**DOCUMENT - 2025-366T
HELIPORT RETROFIT IMPLEMENTATION AT 13653 MCLAUGHLIN ROAD,
CHELTENHAM, PEEL REGIONAL POLICE FACILITY
ADDENDUM 2**

Referring to the above Document 2025-366T - Heliport Retrofit Implementation at 13653 McLaughlin Road, Cheltenham, Peel Regional Police Facility, please note the following:

DRAFTER:	SR	SCALE:	AS NOTED
DESIGNER:	MD	DATE:	25/02/21
APPROVER:	MD	CHECKER:	BRT
PROJECT No:	Z0022639	DRAWING No:	M-102
SHEET No:	2 of 6

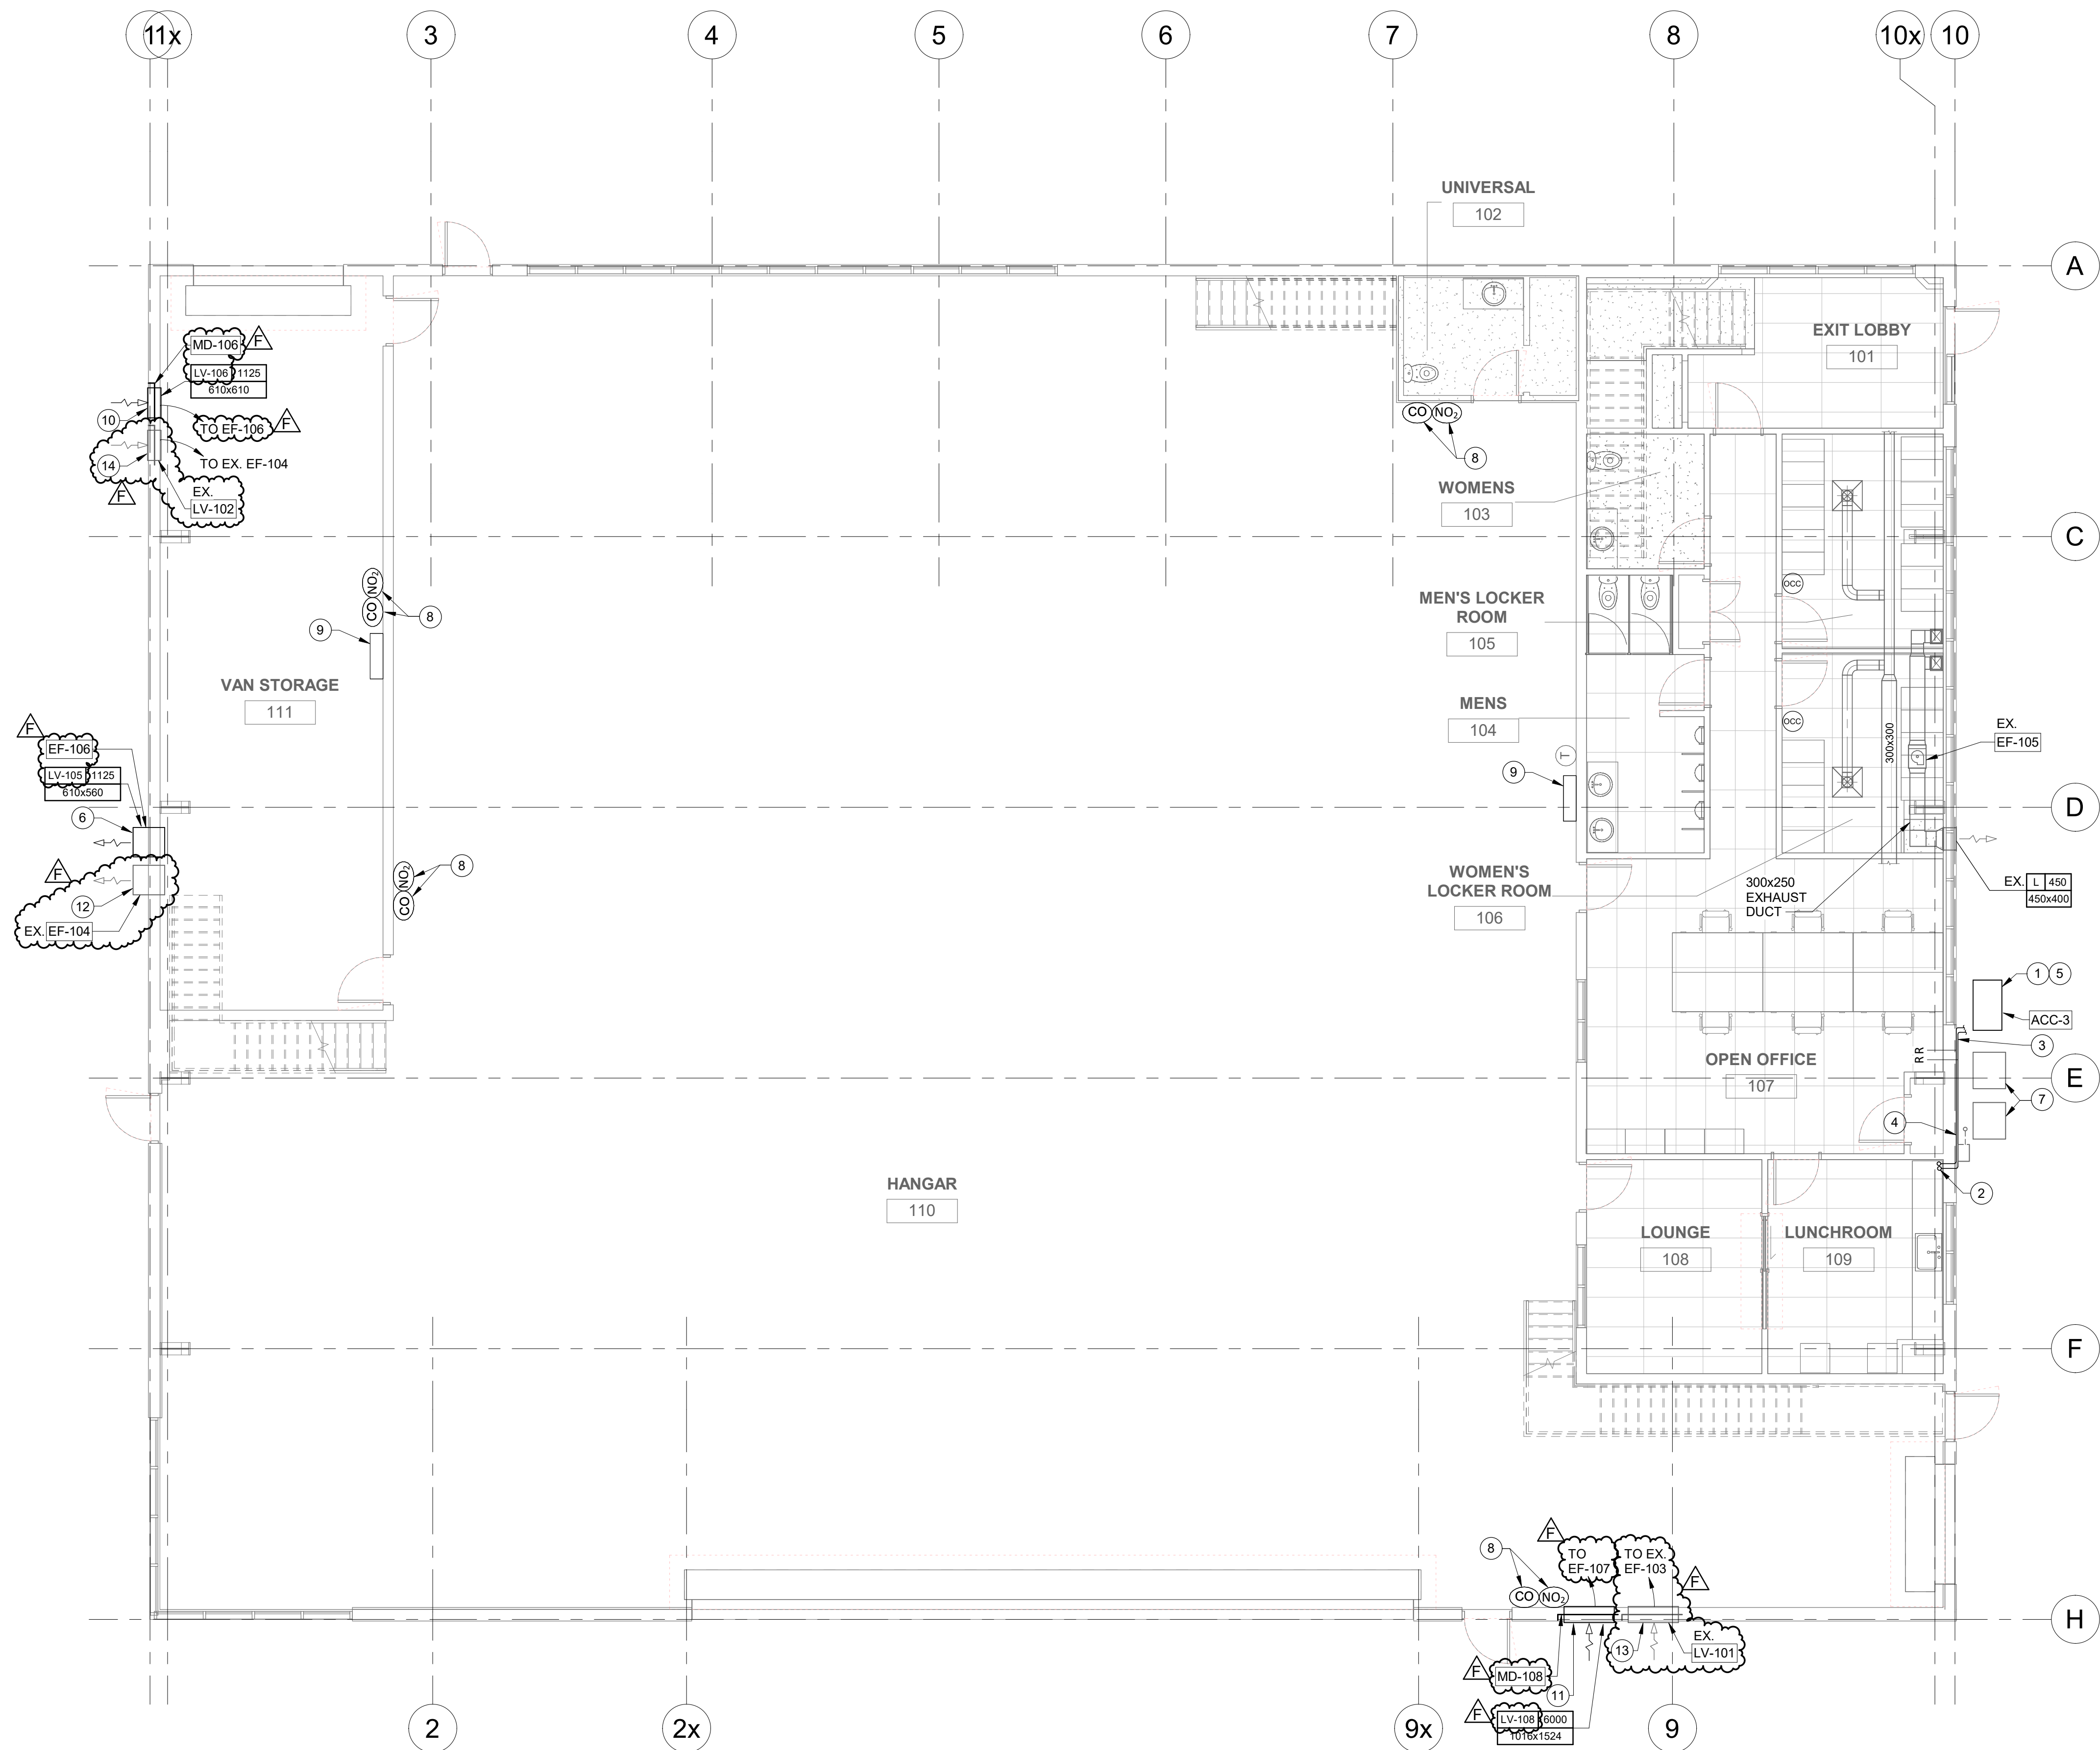
Drawing M102

- Existing Exhaust Fan EF-104, existing exhaust Louver and existing intake Louver LV-102 to remain.
- New Exhaust Fan EF-106 complete with Louver LV-106 to be located beside existing EF-104.
- Existing Louver LV-101 to remain.

- New intake Louver LV-108 complete with Motorized Damper MD-108 to be located beside existing LV-101.
- New intake Louver LV-106 complete with Motorized Damper MD-106 to be located beside existing LV-102.

DISCIPLINE:	
MECHANICAL	
DRAFTER: SR	SCALE: AS NOTED
DESIGNER: MD	DATE: 25/02/21
APPROVER: MD	CHECKER: BRT
PROJECT No: Z0022639	DRAWING No: M-103
SHEET No: 3 of 6

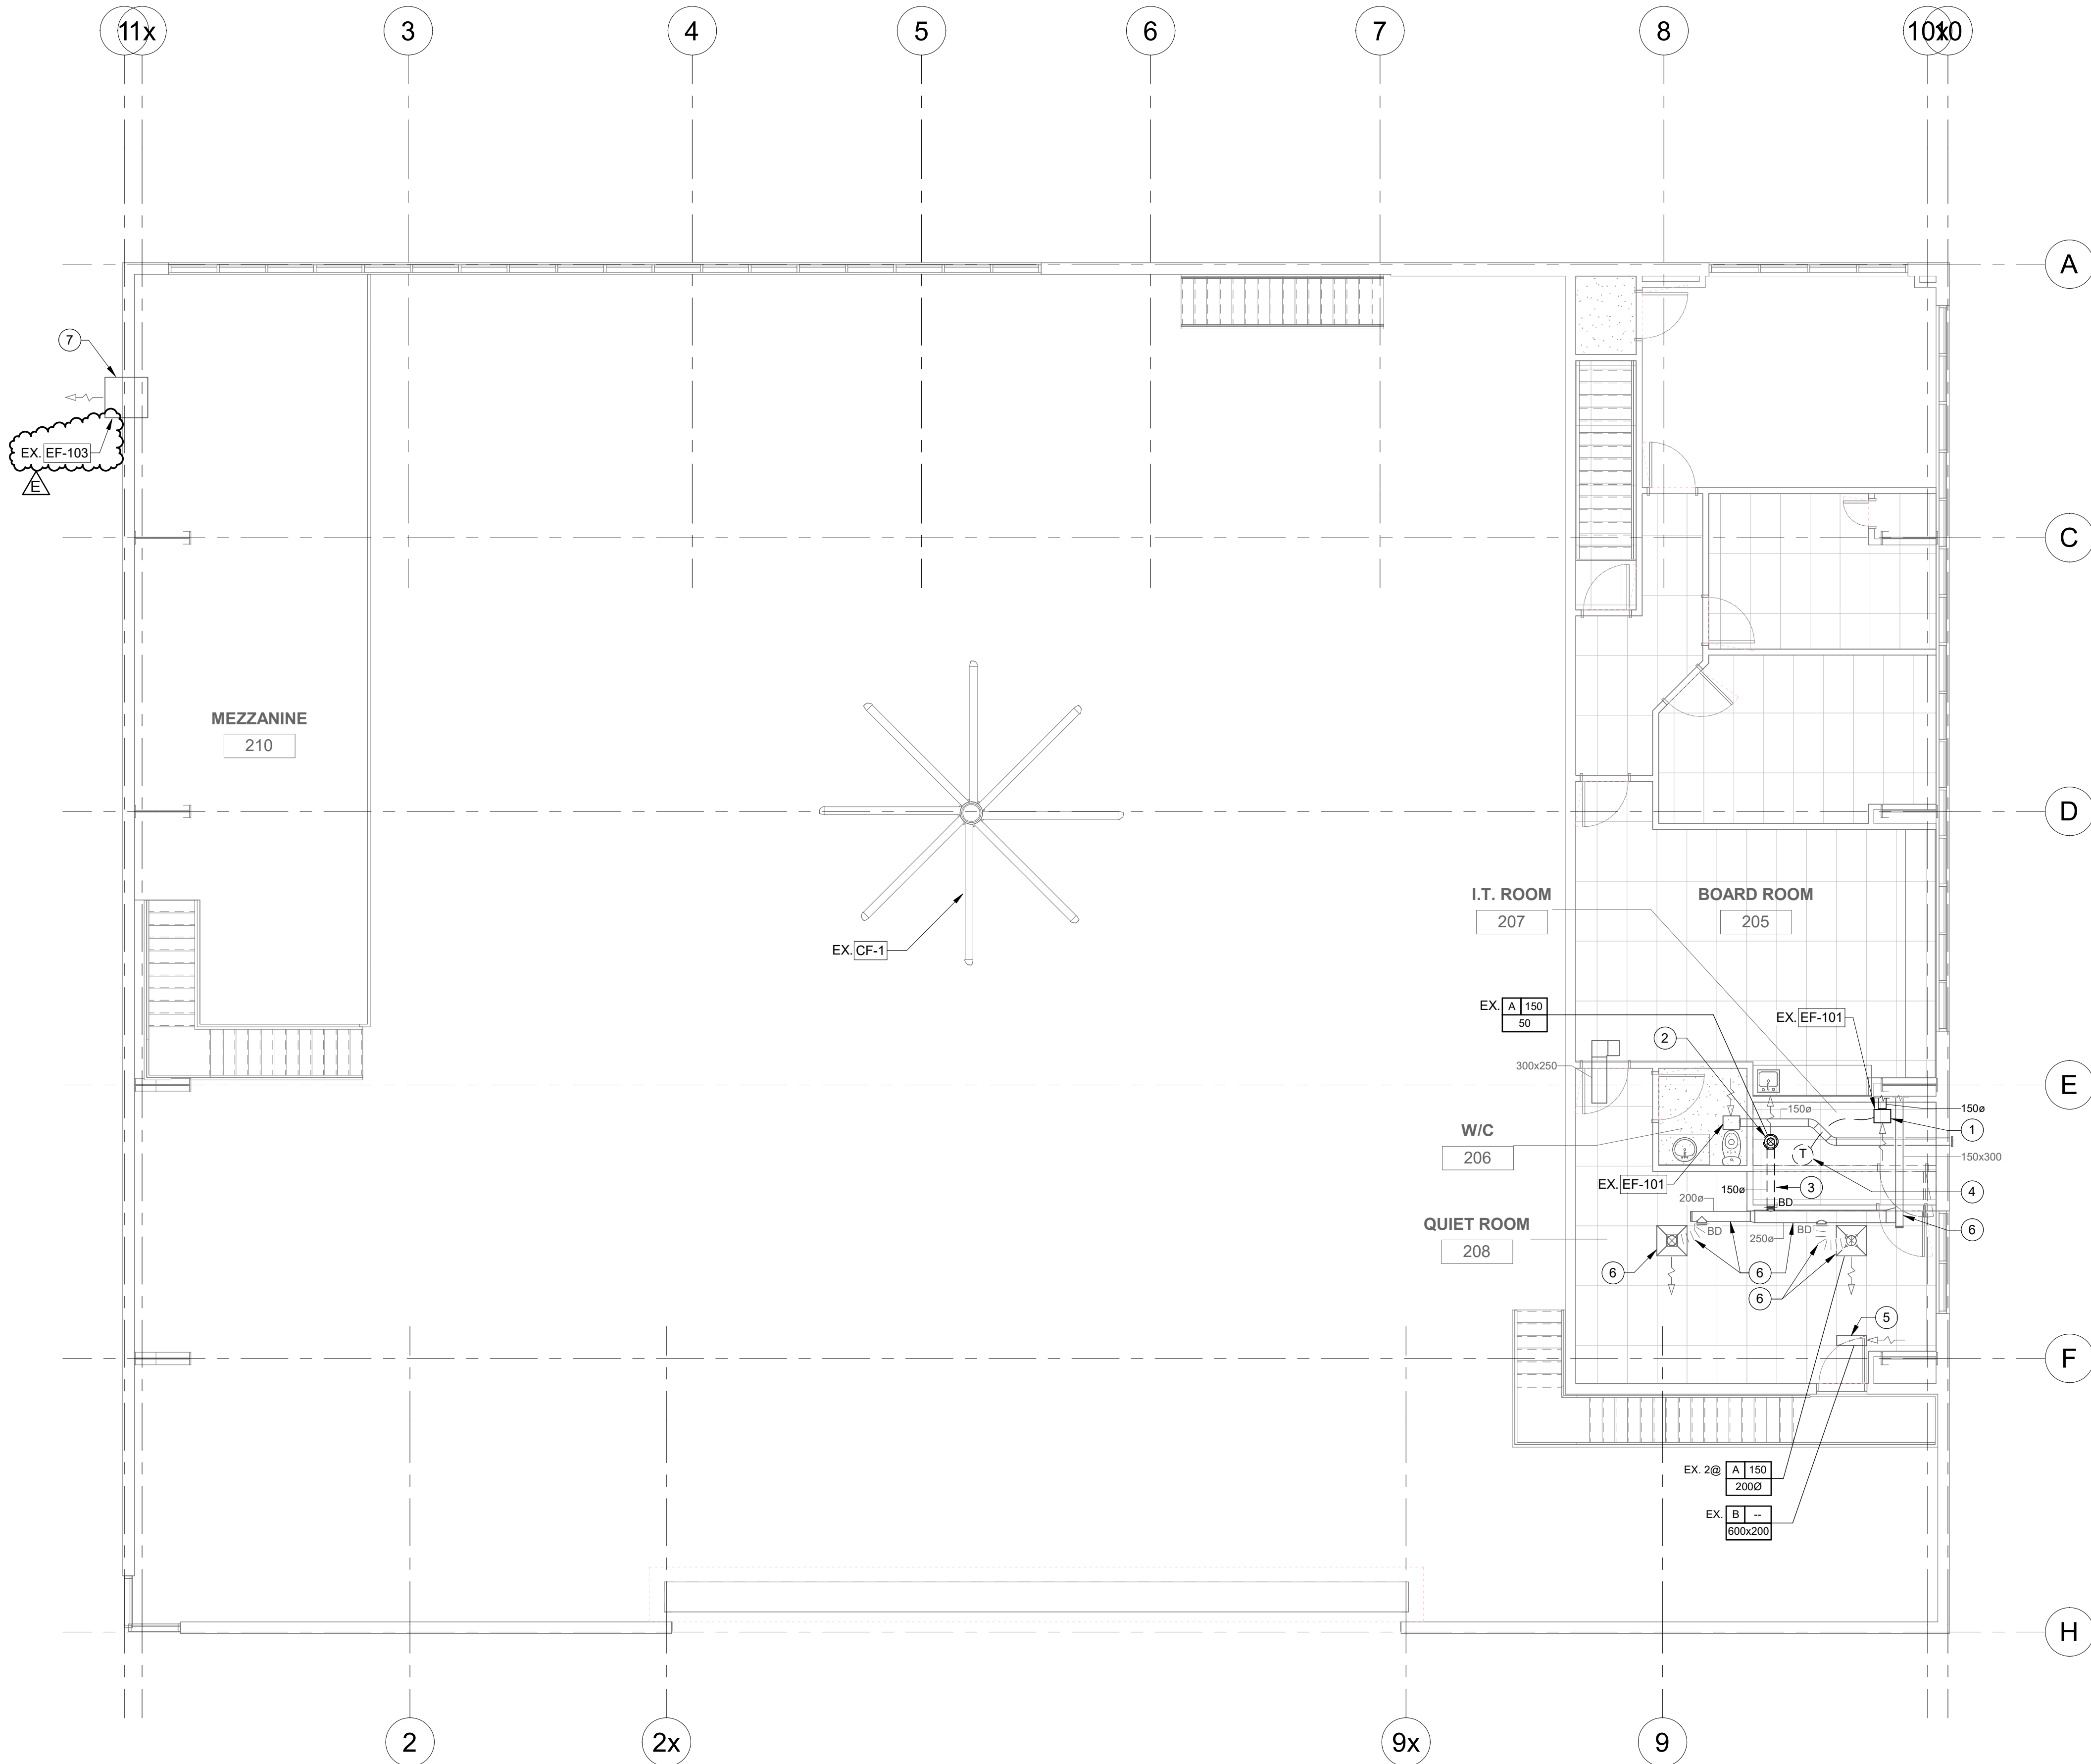
Drawing M103, (see attached drawing for details)

- Existing Exhaust Fan EF-103 and existing exhaust Louver to remain.

DISCIPLINE:	
MECHANICAL	
DRAFTER:	SR
DESIGNER:	MD
APPROVER:	MD
PROJECT No.:	Z0022639
SHEET No.:	4 of 6
SCALE:	AS NOTED
DATE:	25/02/21
CHECKER:	BRT
DRAWING No.:	M-104

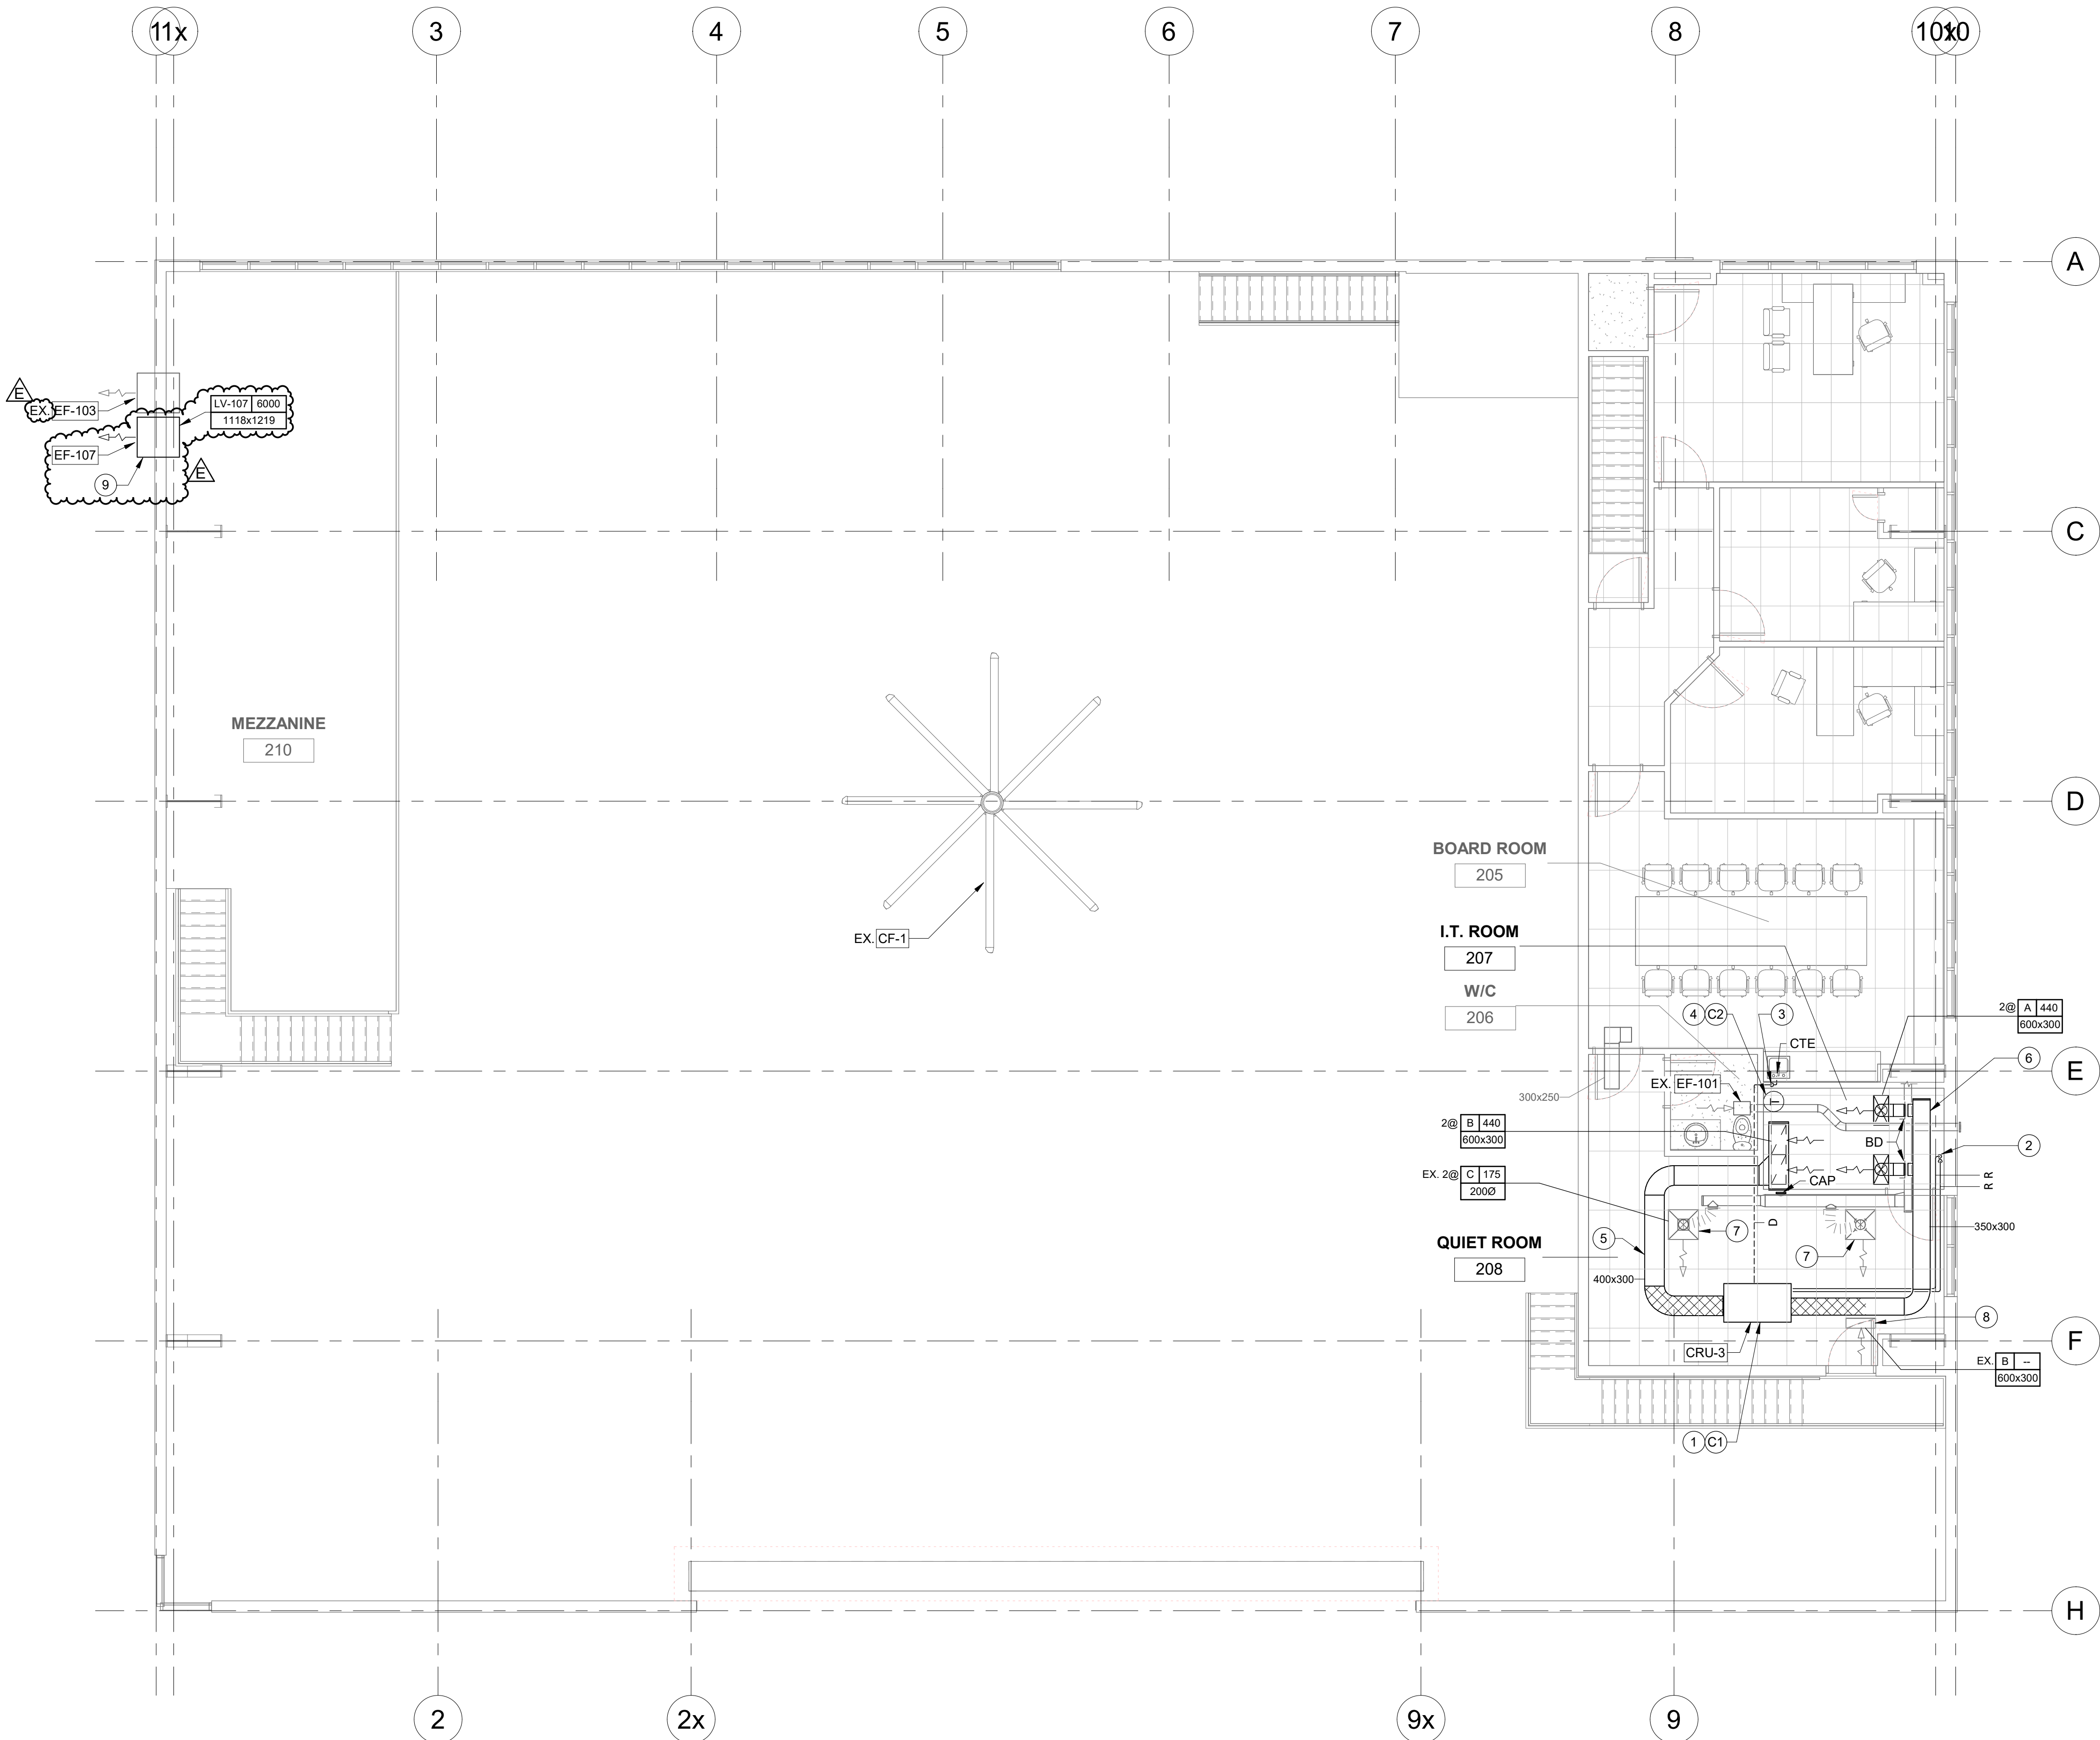
Drawing M104, (see attached drawing for details)

- New Exhaust Fan EF-107 complete with Louver LV-107 to be located beside existing EF-103.

Drawing M-104 indicates ceiling fan as existing (EX CF-1). Based on site observation, it appears there is no ceiling fan at noted location.

Owner has retained vendor to install separately. Work is not yet complete.
